Radiators for MAN EURO 4 + 5 Very urgent information

BHS Radiator p/n for MAN EURO 4 + 5

Very urgent information about following radiators for MAN EURO 4 + 5

**EURO 4 + 5 version
OLD**

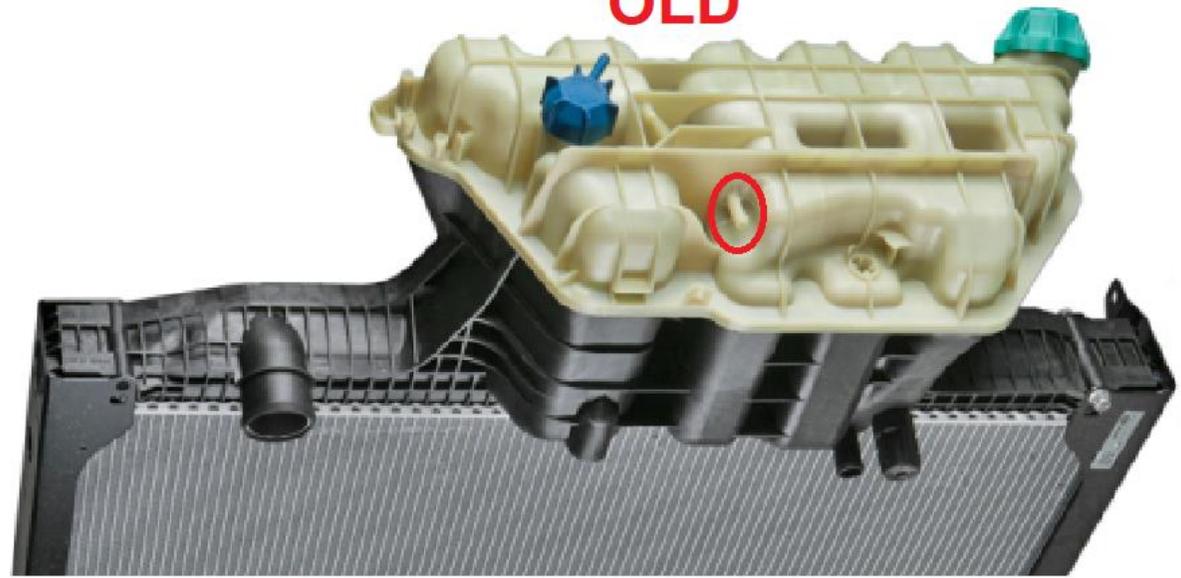
- Euro 4 + 5 version manufactured until April 2019

Radiator for MAN EURO 4 + 5

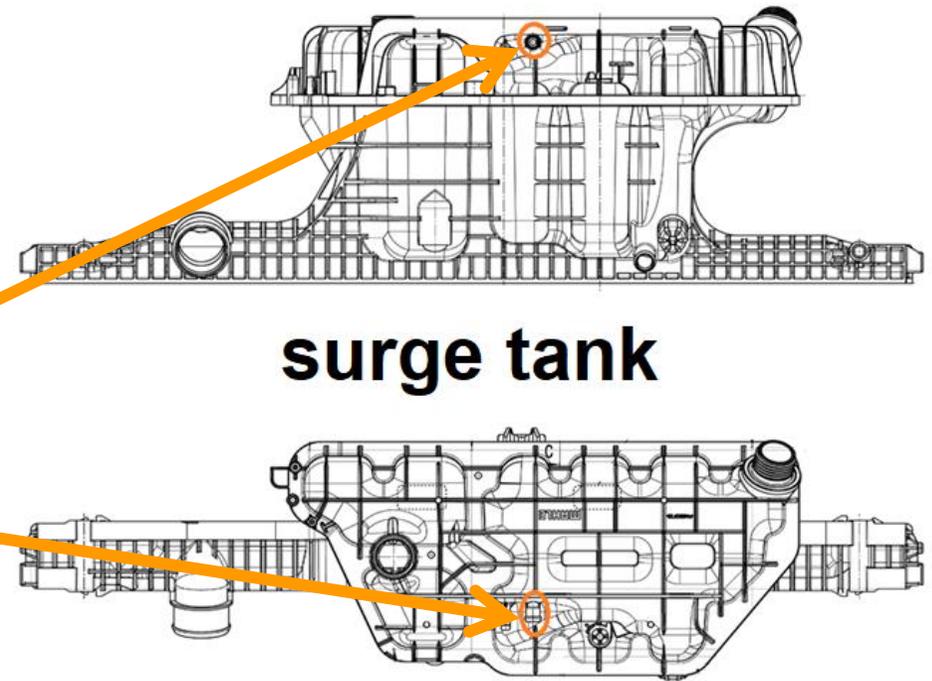
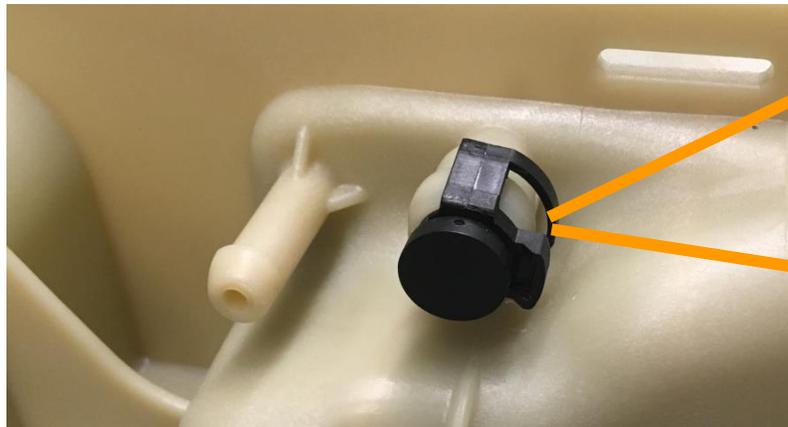
- Euro 6 version manufactured after April 2019
- One more connector is added
- **For application EURO 6 vehicles only!**
- Connector here marked in orange

Radiator for MAN EURO 4 + 5

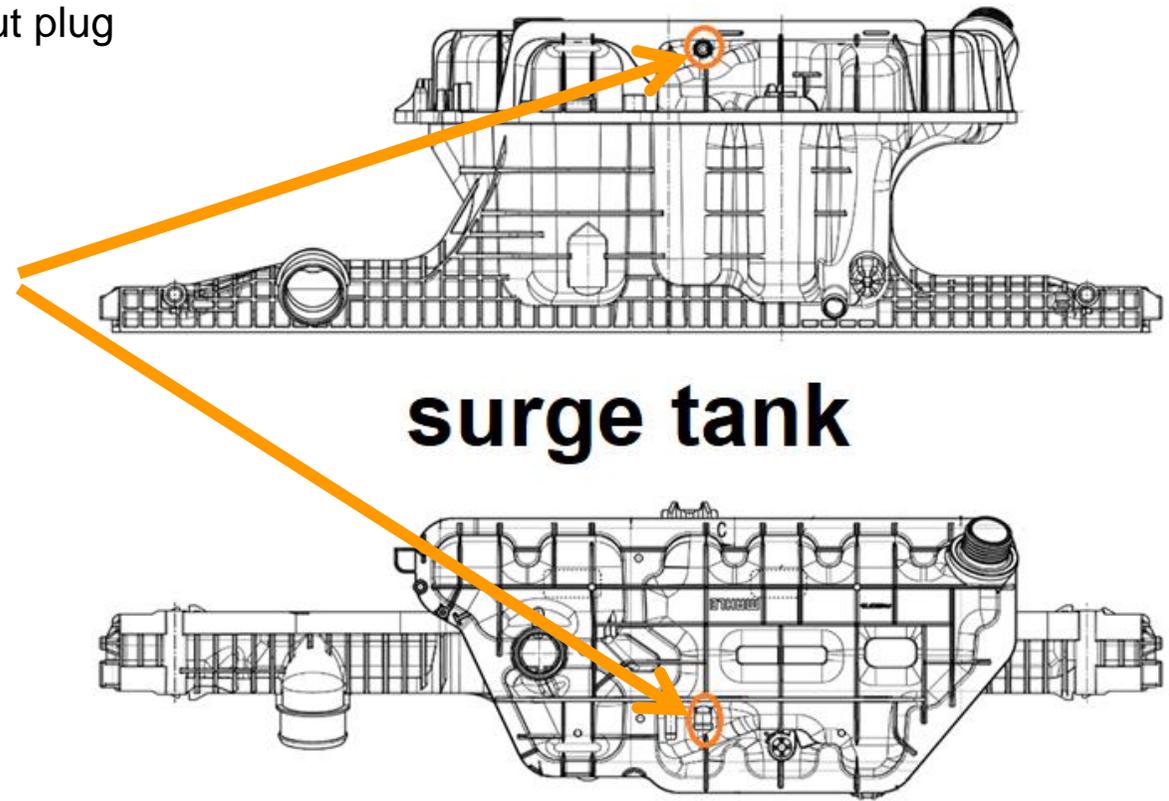
- Euro 4 + 5 compatible with plug OE no. 36.06140-0045*
- Valid for all radiators manufactured after April 2019
- Radiators are being delivered without plug

- **Plug OE no. 36.06140-00454 must be ordered from the OES-Channel!**
